# Access Compliance Report

## Public Rights-of-Way

### (Curb Ramps)

Intersection ID: 15843	Main Street: N_SHARON_AMITY_RD	Cross Street: KIPLING_DR	Location: S
ADA ID: 4ADAA0AF46DF	Ramp Type: PerpDiag	Initial Pass/Fail: Pass	Overall Compliance: No
Severity Score: 2.5			
Codes/Mitigation Info/Possible Solution		Field Measurements/Component Compliance

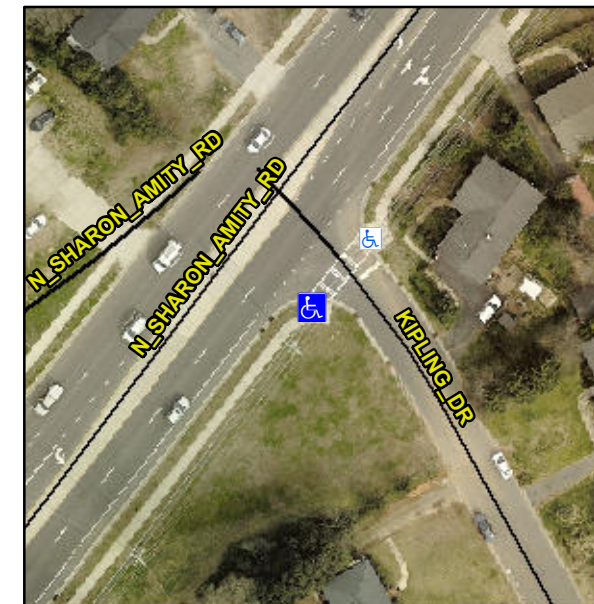
Surveyor Notes:

**Not Found, R305.1.4**

**Remove & Replace Curb Ramp With Two New Directional Ramps or Equivalent.**
